ADDENDUM NO. 2

City of Lakewood Angle Lane/Elwood Drive Pedestrian Improvements City Project No. 302.0156

Date of Issue: April 21, 2023

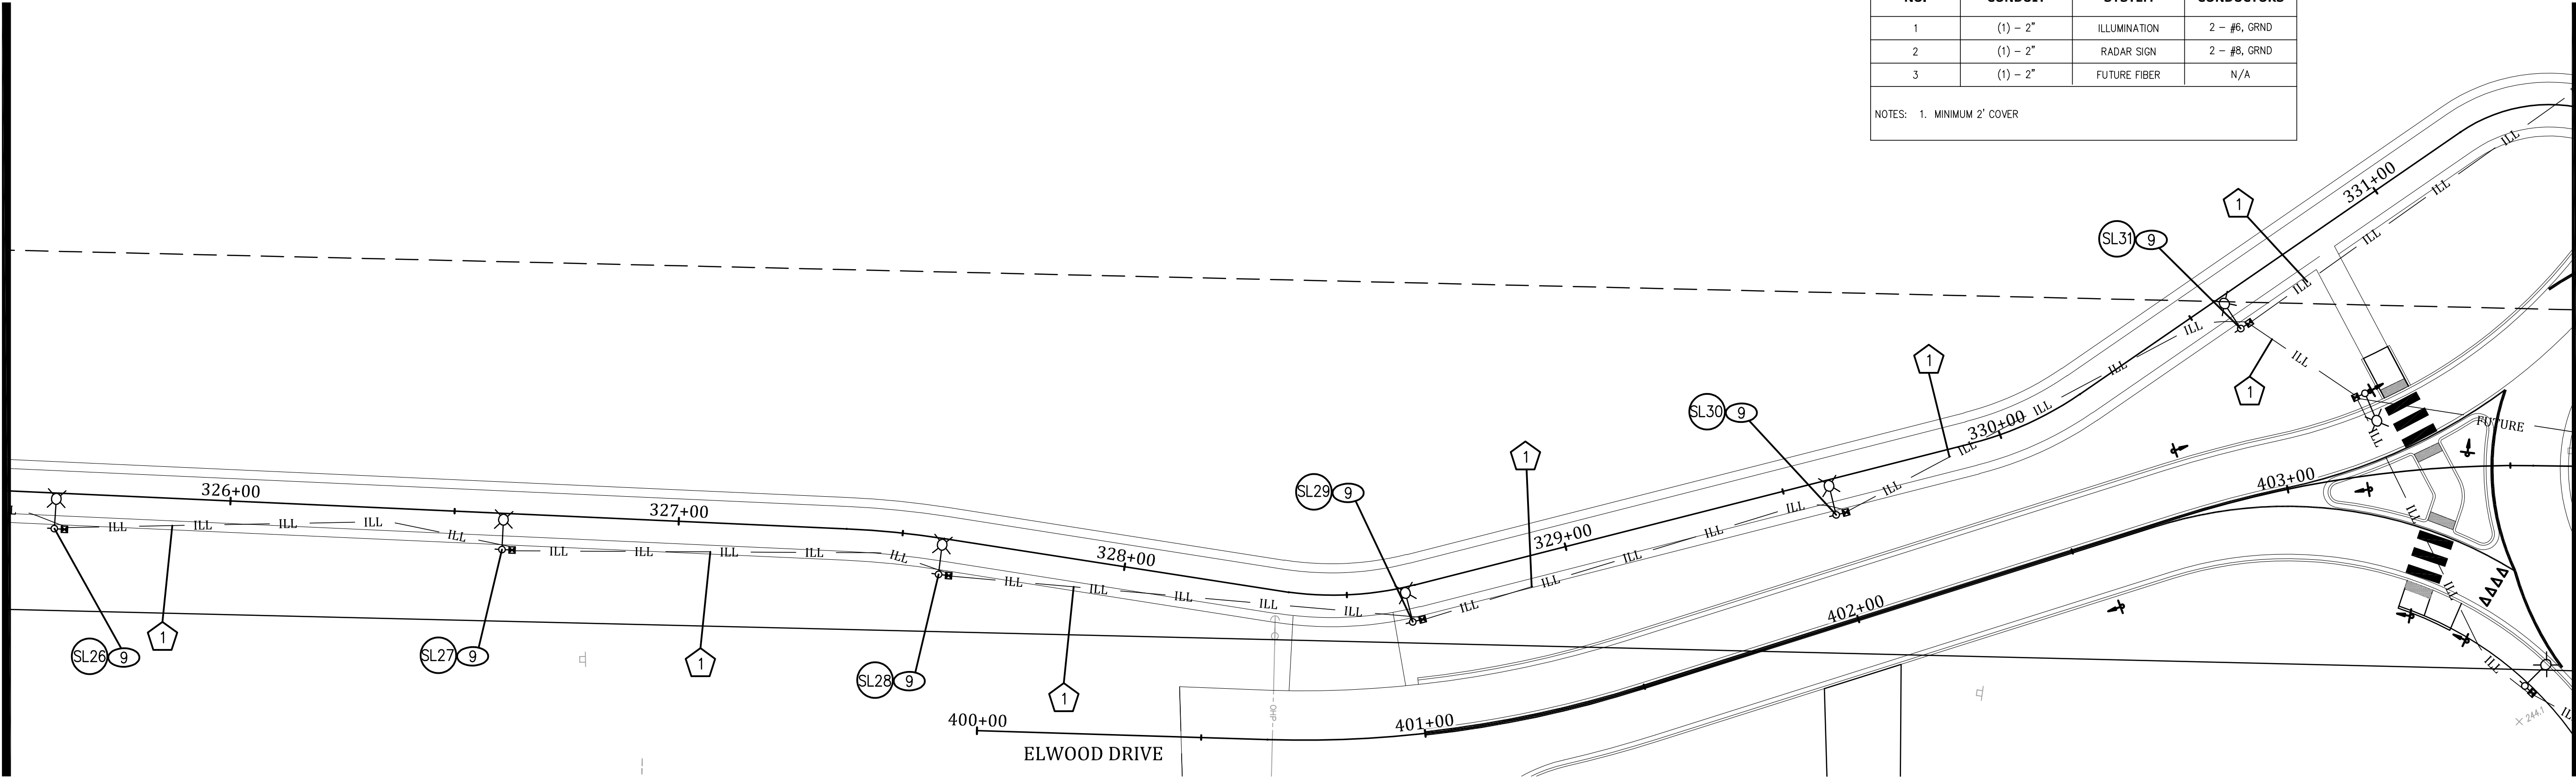
1. **Sheet 41-44 (IC3-IC6) – Remove and Replace Sheets.** Two luminaires on IC3 were noted as SL1; one at 300+60 and one at 301+60. This modification provided the information in the table for SL1 at Sta 300+60 and renumbered street lights north of that. There are 37 street lights on the project, not 36 as previously numbered.

No.	Release/Revision	Re. Date	Re. By	Designed By:	Project Name:	Job No.
1	RENUMBER LIGHT POLES	4/21/23	TSP	T. POKSWINSKI	ANGLE LANE / ELWOOD DRIVE PEDESTRIAN IMPROVEMENTS	302.0156
				Drawn By: T. POKSWINSKI		Drawing No. IC5
				Checked By: C. T. HILL		Sheet 43 of 49
				Approved By: P. BUCICH		
				Project Start Date: 12/06/22 Drawing Scale: AS SHOWN	ILLUM./CHANNELIZATION PLAN - STA. 320+50 TO STA. 331+50	
				Electronic File Name: 302.0083

LUMINAIRE SCHEDULE						
SL#	ALIGN	STATION	OFFSET	HEIGHT	MAST ARM	HEAD WATTAGE
21	ELWOOD	320+60	9' RT	15'	4'	68
22	ELWOOD	321+60	9' RT	15'	4'	68
23	ELWOOD	322+60	9' RT	15'	4'	68
24	ELWOOD	323+60	9' RT	15'	4'	68
25	ELWOOD	324+60	9' RT	15'	4'	68
26	ELWOOD	325+60	9' RT	15'	4'	68
27	ELWOOD	326+60	9' RT	15'	4'	68
28	ELWOOD	327+60	9' RT	15'	4'	68
29	ELWOOD	328+60	9' RT	15'	4'	68
30	ELWOOD	329+60	9' RT	15'	4'	68
31	ELWOOD	330+60	9' RT	15'	4'	68

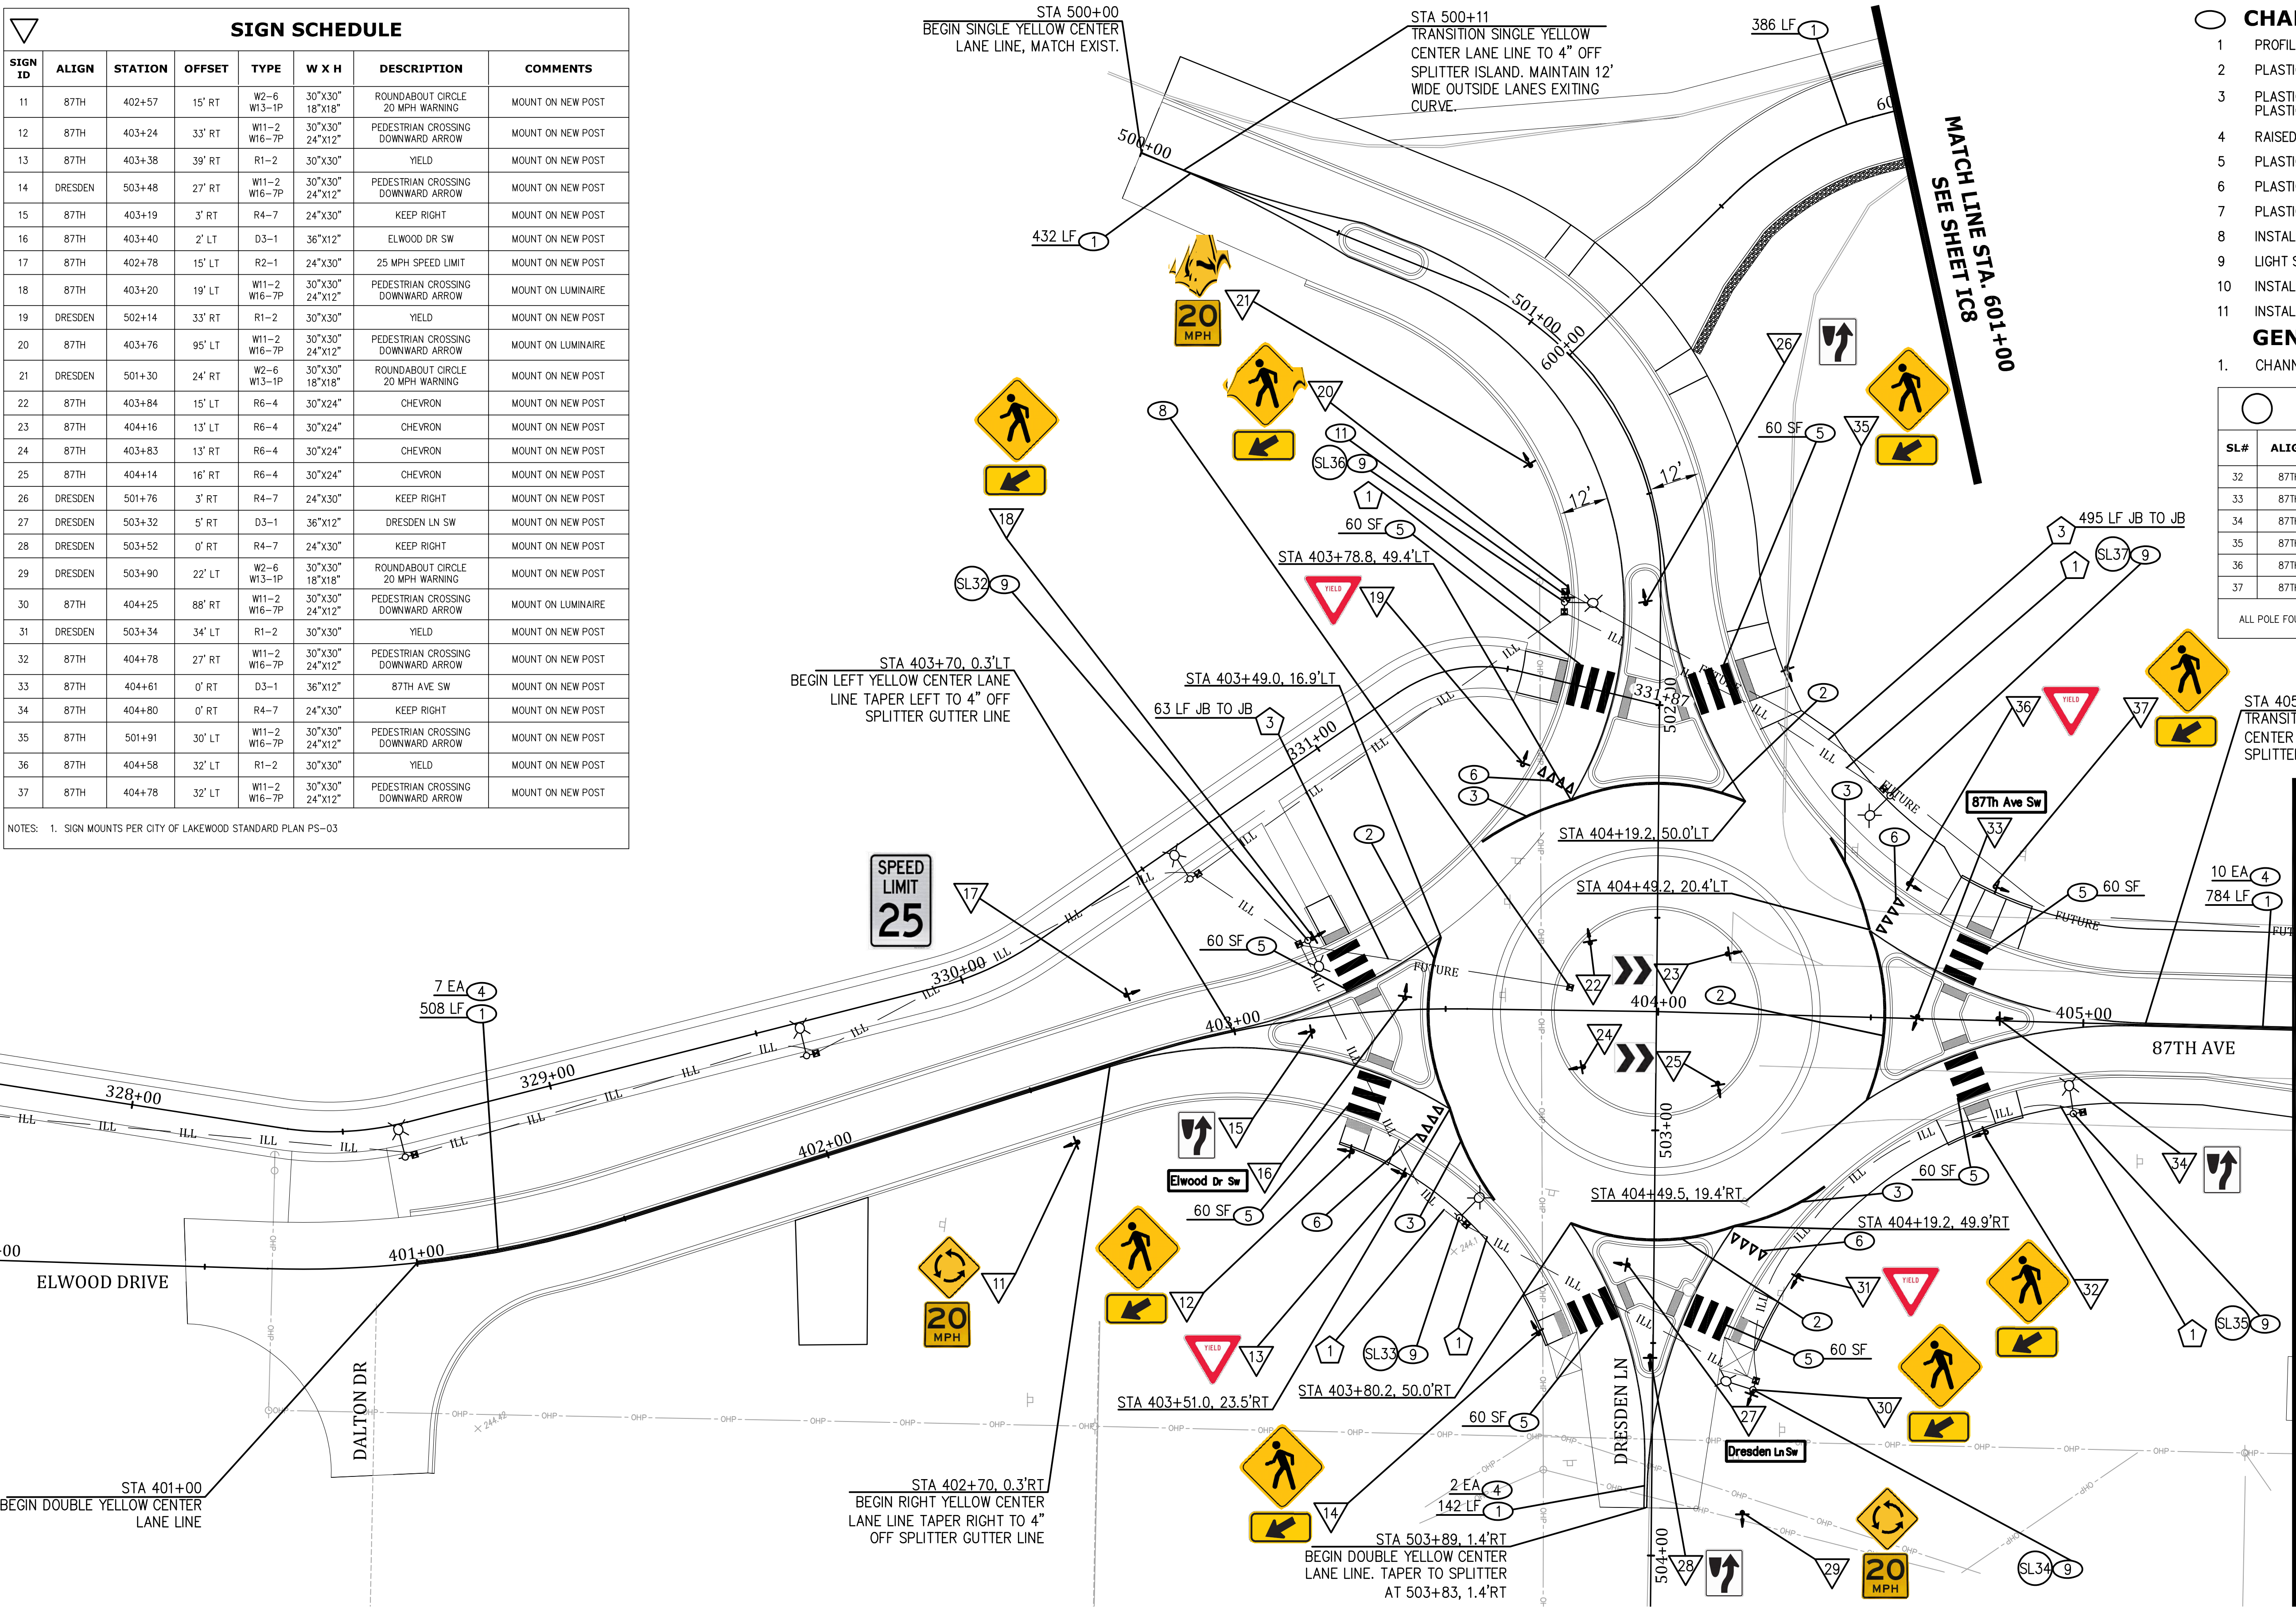
No.	Release/Revision	Re. Date	Re. By	Designed By: T. POKSWINSKI			Project Name:	ANGLE LANE / ELWOOD DRIVE PEDESTRIAN IMPROVEMENTS	Job No.	302.0156
1	RENUMBER LIGHT POLES	4/21/23	TSP	Drawn By: T. POKSWINSKI			Drawing No.		IC6	
				Checked By: C. T. HILL			Drawing Name: ILLUM./CHANNELIZATION PLAN - STA. 400+00 TO STA. 405+50			
				Approved By: P. BUCICH						
				Project Start Date: Drawing Scale: 12/06/22 AS SHOWN						
				Electronic File Name: 302.0083

LUMINAIRE SCHEDULE						
SL#	ALIGN	STATION	OFFSET	HEIGHT	MAST ARM	HEAD WATTAGE
32	87TH	403+20	19' LT	35'	4'	85
33	87TH	403+54	50' RT	35'	4'	85
34	87TH	404+25	88' RT	35'	4'	85
35	87TH	404+98	22' RT	35'	4'	85
36	87TH	403+76	95' LT	35'	4'	85
37	87TH	404+53	52' LT	35'	4'	85
ALL POLE FOUNDATIONS SHALL BE 2' IN DIAMETER. 15' POLE FOUNDATION DEPTH SHALL BE 3'.
